**RE: Hanson Sancrox Quarry SSD Application No. 7293**

Accordingly, we wish to make the following submission on the proposed Hanson Sancrox Quarry expansion SSD No. 7293 documentation:

"C"

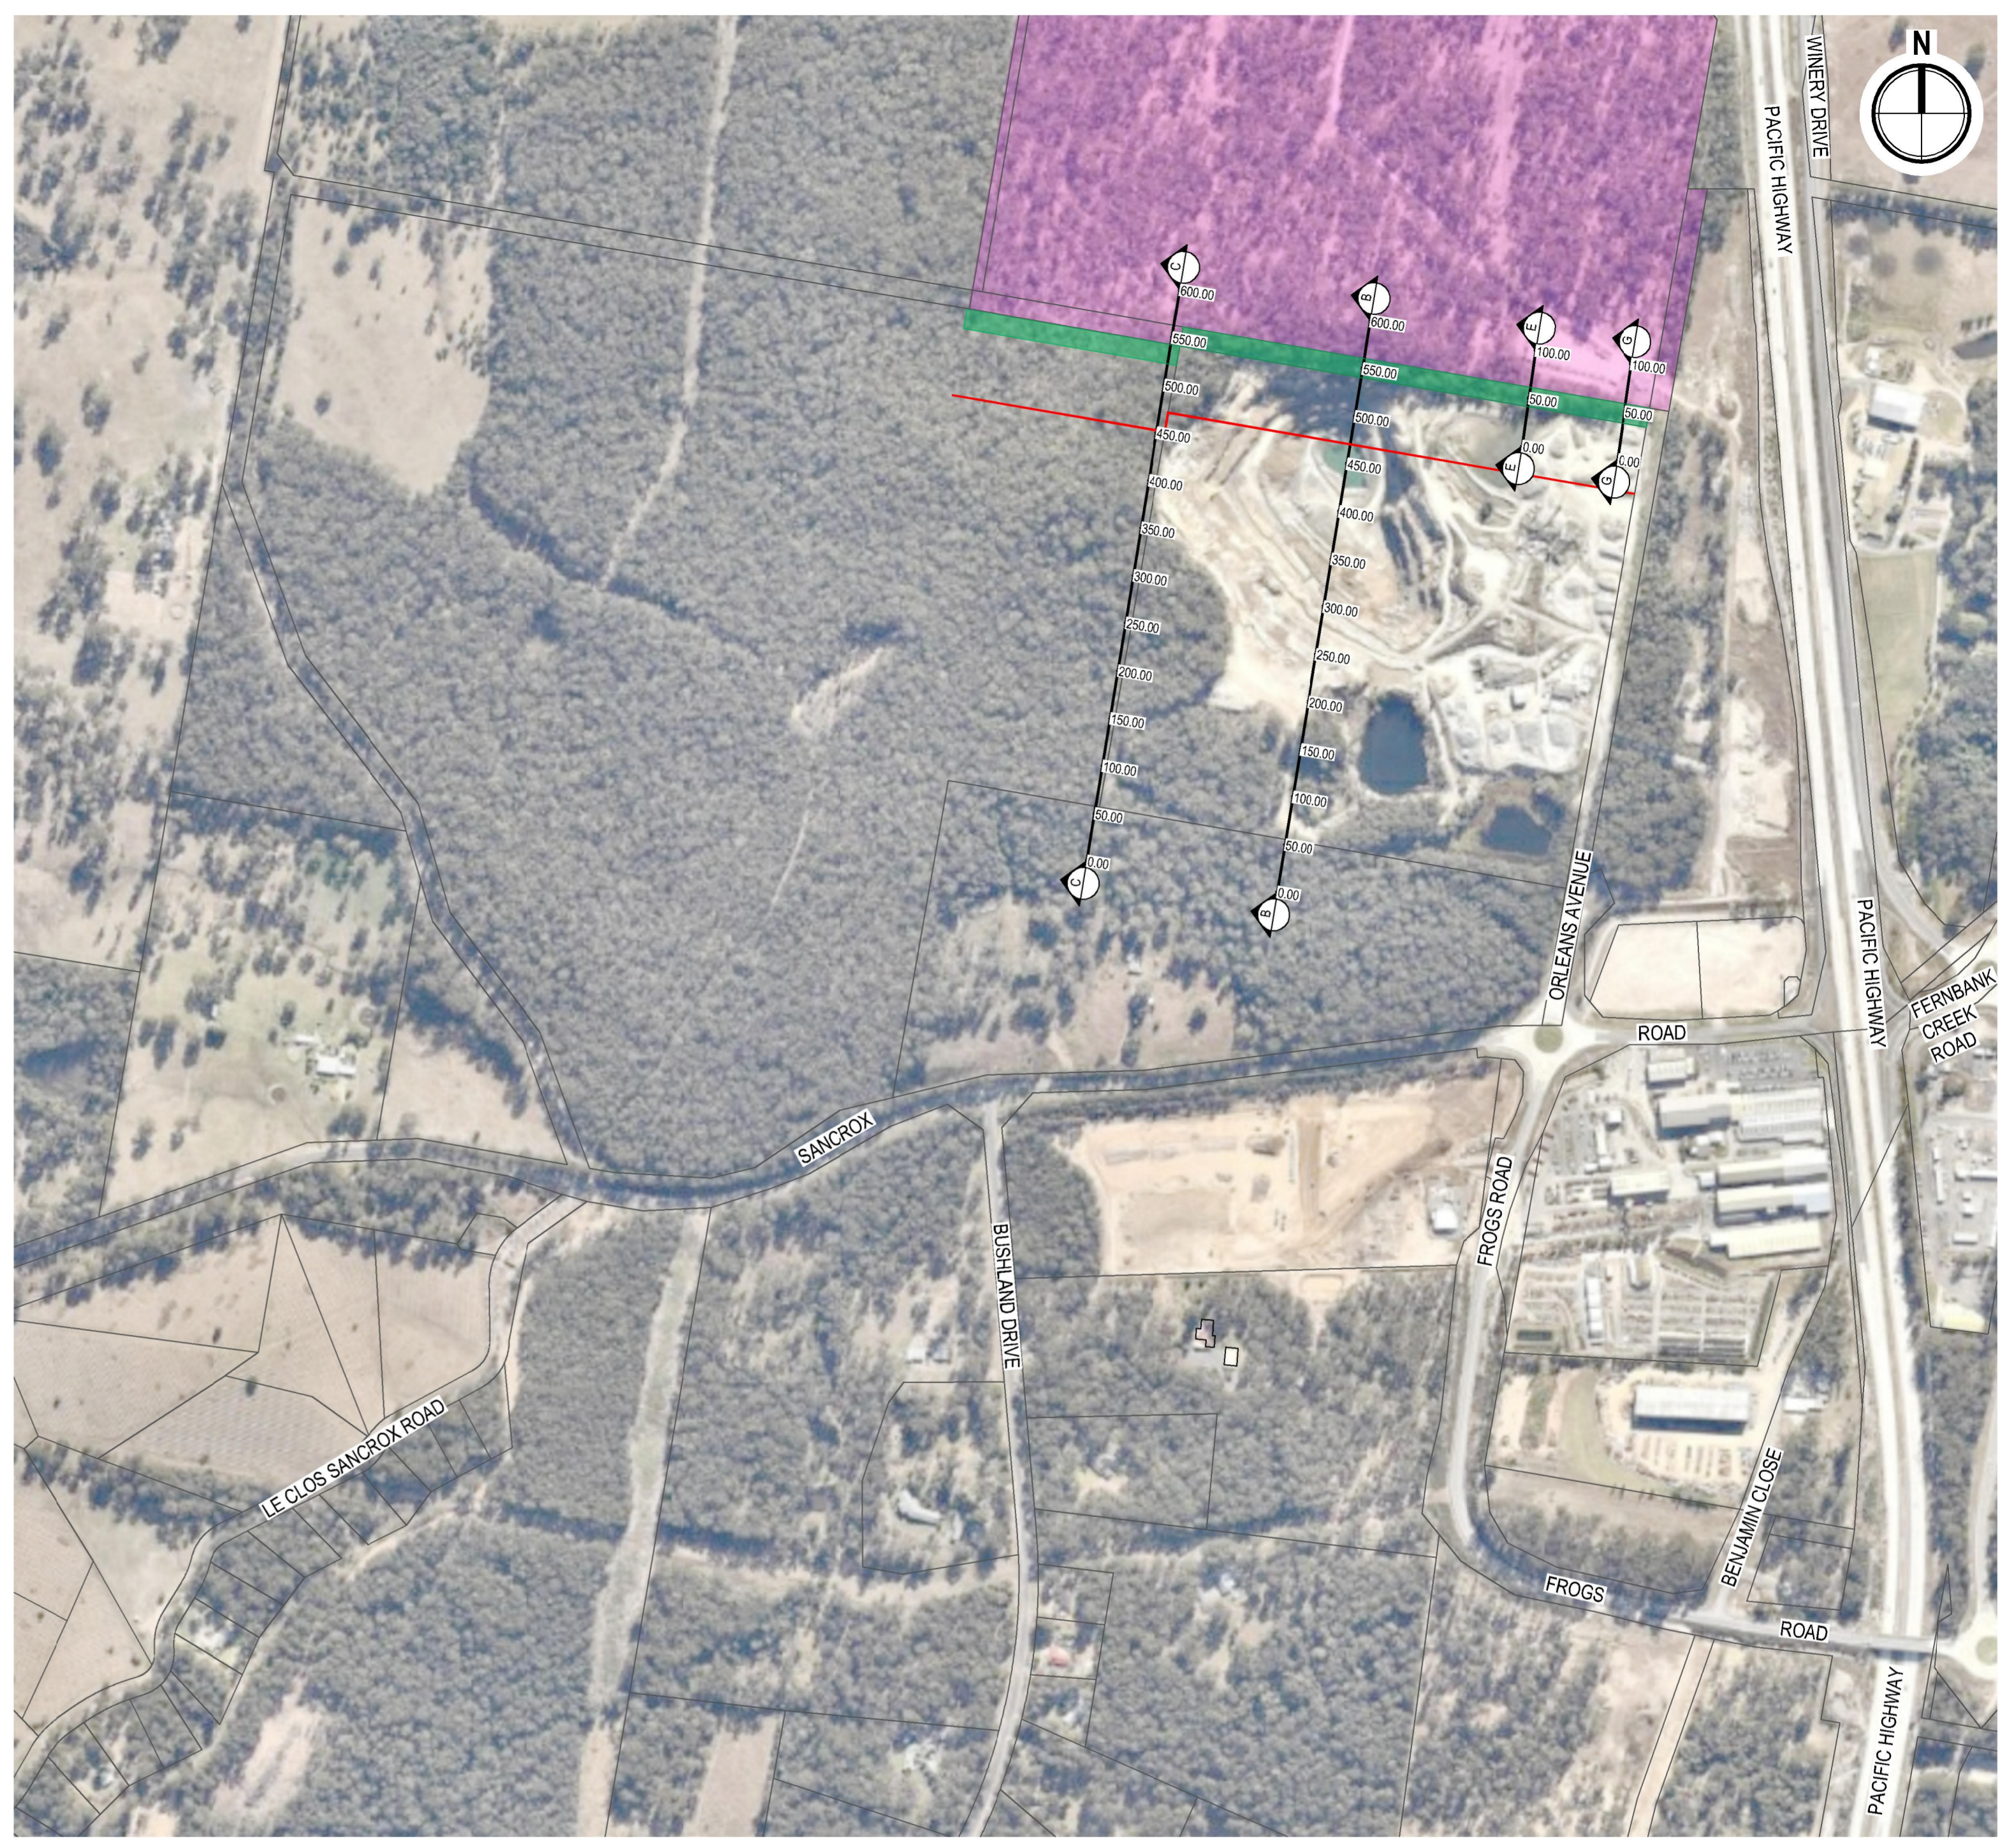
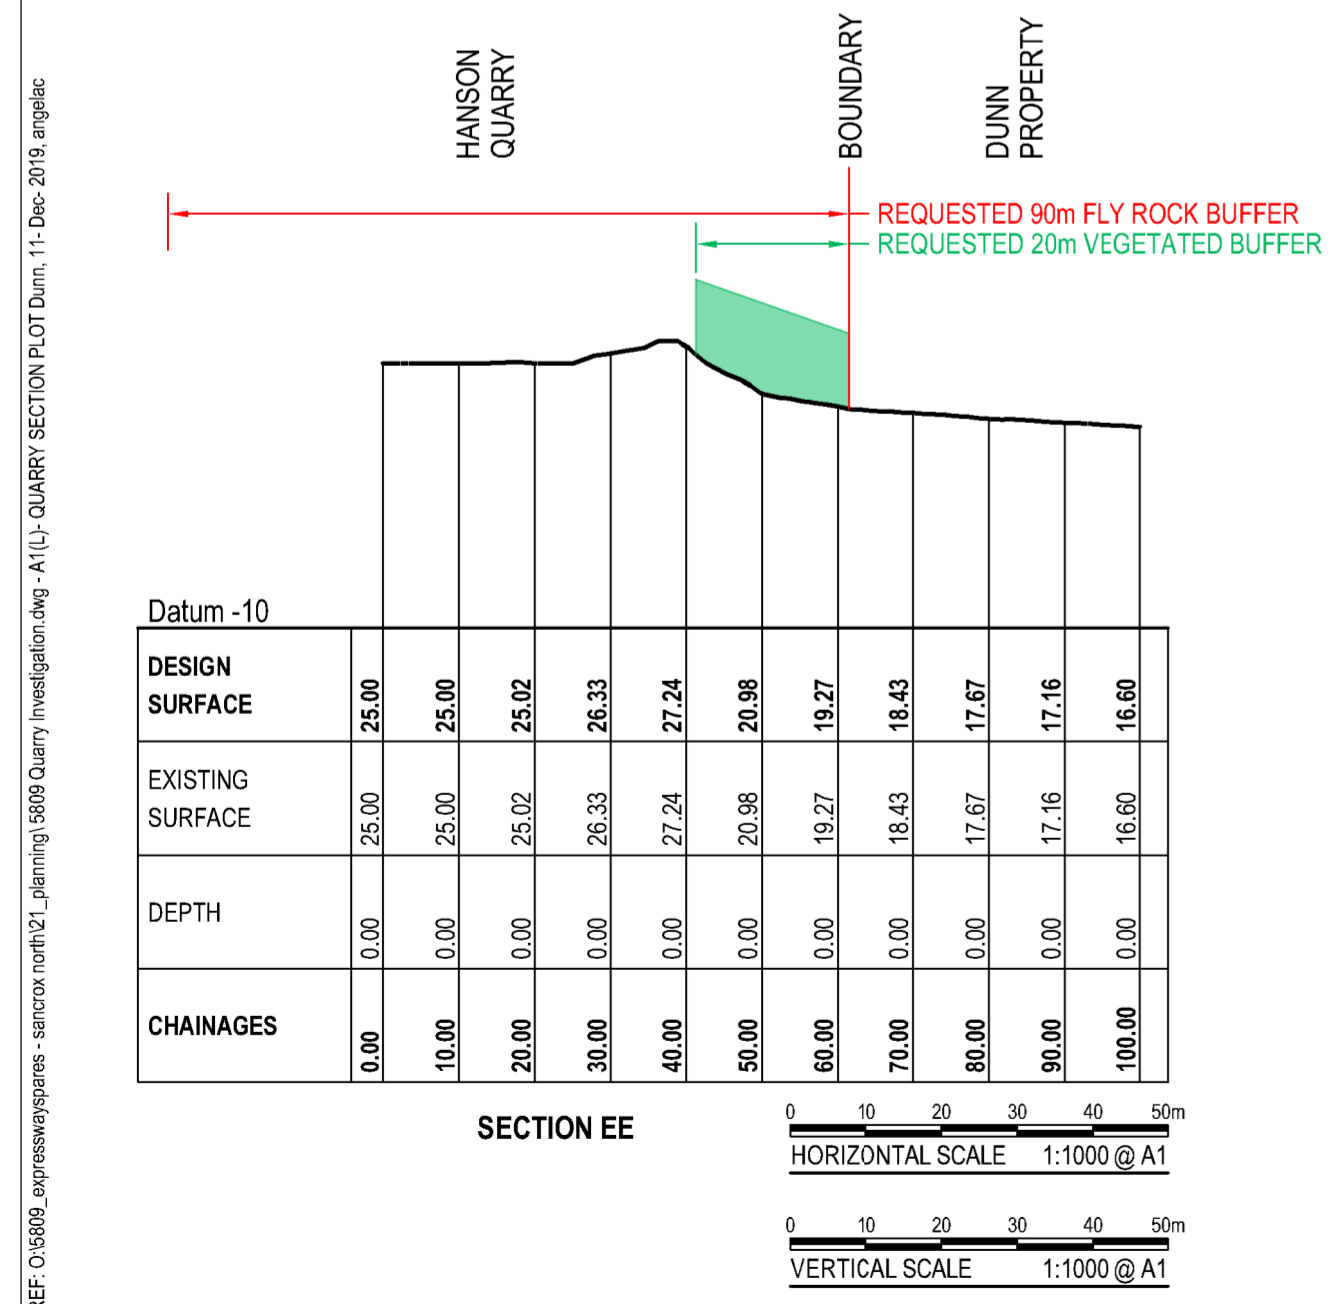
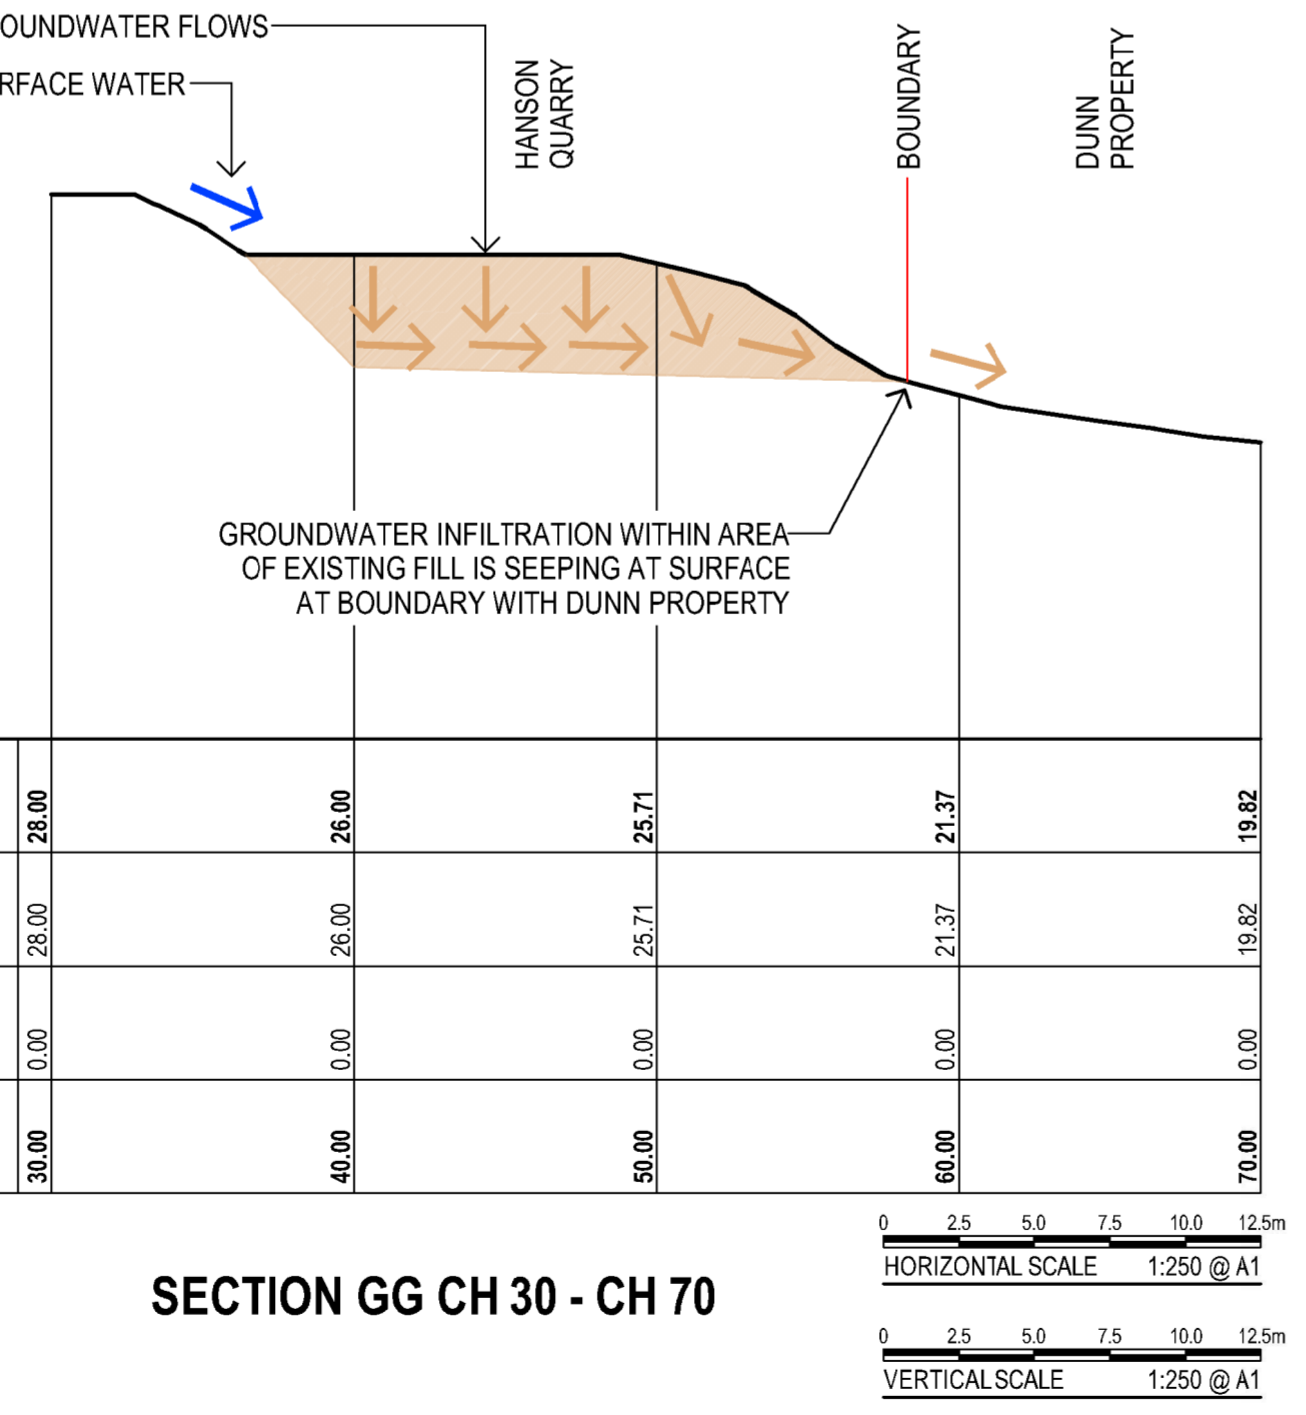
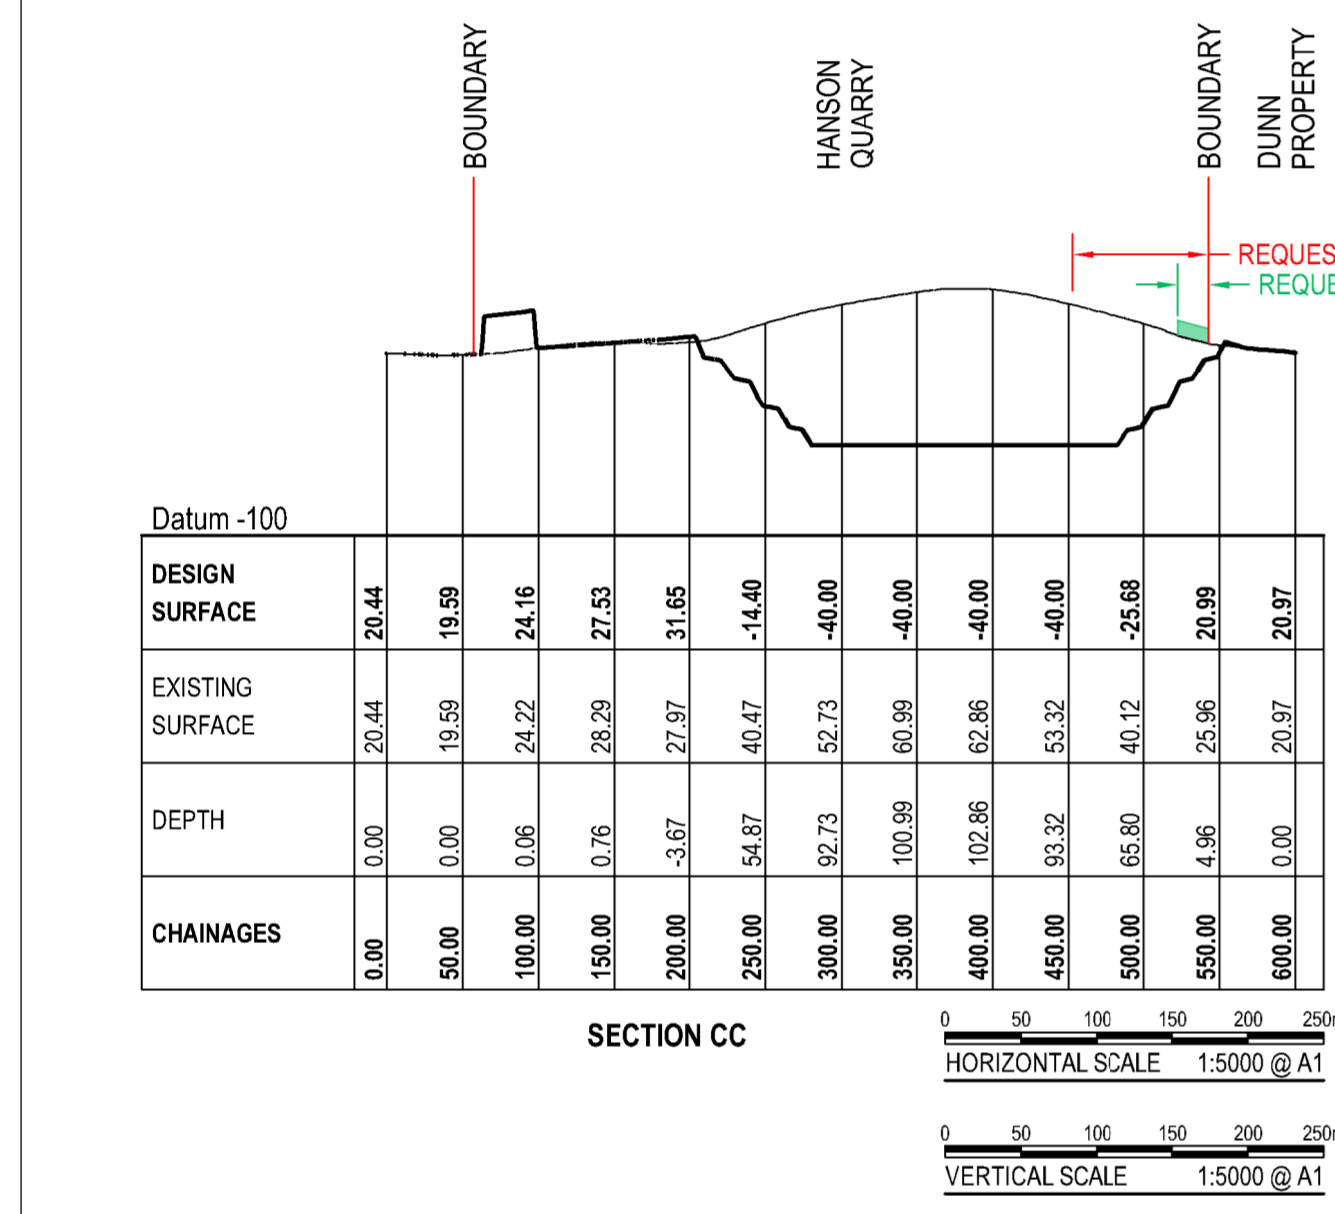
More importantly, the proposal does not provide any flyrock buffers and these must be contained within quarry property. The SKM/Terrock report calculated a 90m buffer for flyrock and accordingly any proposed blasting should be at least 90 metres from the Southern boundary of our property and the proposal should be modified accordingly.
